ABINGTON TOWNSHIP

BOARD OF COMMISSIONERS COMMITTEE OF THE WHOLE

A G E N D A
March 11, 2021
7:00 PM

f. Consider and discuss approving the Land Development application, LD-21-01, AQUA Pennsylvania, Inc. at property address 315 Chelsea Avenue, Glenside to upgrade and expand the North Hills Pump Station to implement a PFAS treatment system.

Project Number	B/O	Total	Drawing Number
507402365	5	66	C103

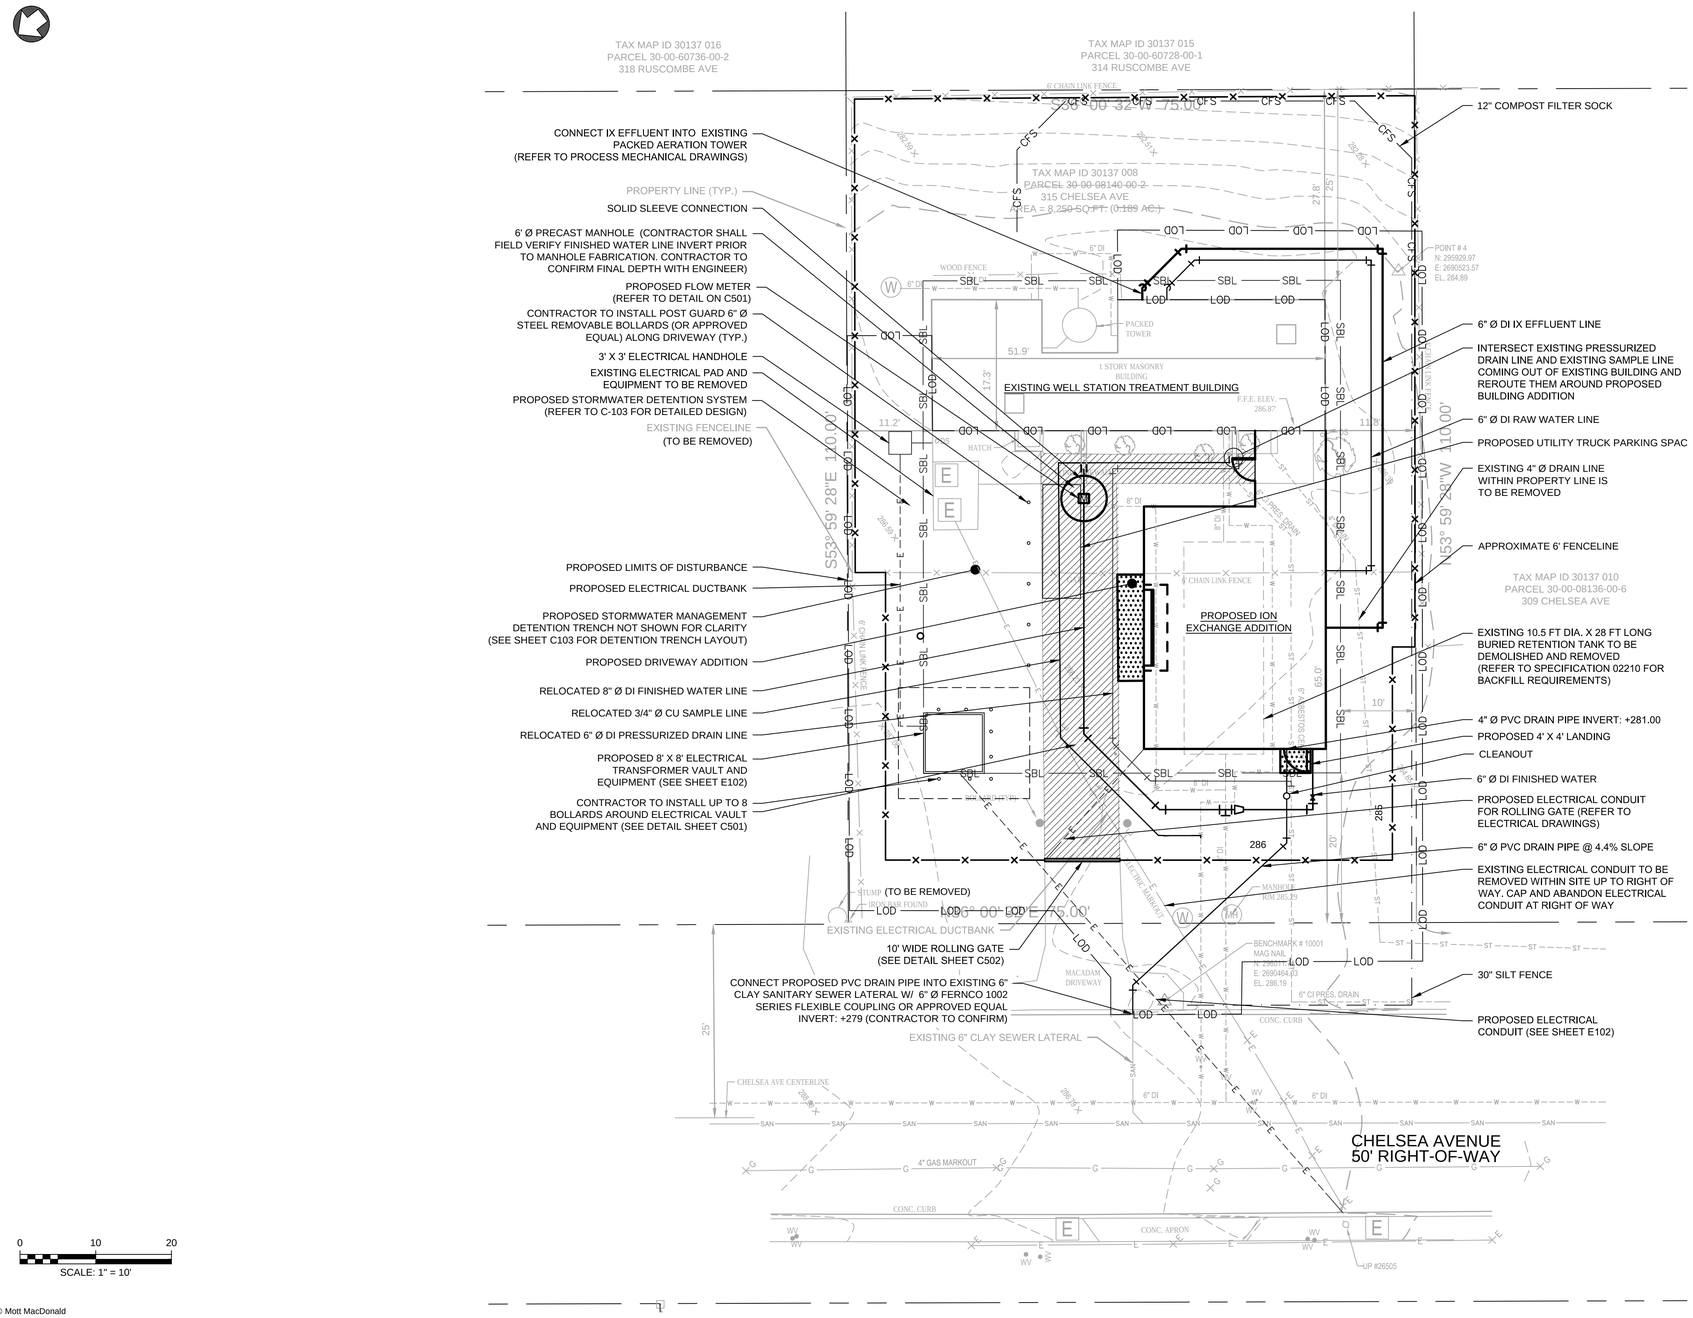
18. Per §142-302.B.(1)(m), the Stormwater Management Drainage Plan (Sheet C103) shall include the following signature block for the Municipality: *"(Municipal official or designee), on this date (date of signature), has reviewed and hereby certifies that the SWM site plan meets all design standards and criteria of the Municipal Ordinance No. (number assigned to the Ordinance)."*

22. Per §142-302.B.(2)(b)[25], a statement, signed by the applicant, acknowledging that any revision to the approved drainage plan must be approved by the Municipality, and that a revised erosion and sediment control plan must be submitted to the Municipality or Conservation District for approval. Please place this statement on the drainage plan (Sheet C103).

23. Per §142-302.B.(2)(b)[26], The following signature block for the Design Engineer shall be added to Stormwater Drainage Plan (Sheet C103):
    "I, (Design Engineer), on this date (date of signature), hereby certify that the drainage plan meets all requirements of the Department of Environmental Protection's (DEP's) regulations and this chapter."

MM Response (3/4/21): The specified signature block has been added to the Stormwater Management and Drainage Plan (Sheet C103).

MM Response (3/4/21): The specified statement, to be signed during the recording process, has been added to the Stormwater Management and Drainage Plan (Sheet C103).

MM Response (3/4/21): The specified statement, to be signed during the recording process, has been added to the Stormwater Management and Drainage Plan (Sheet C103).
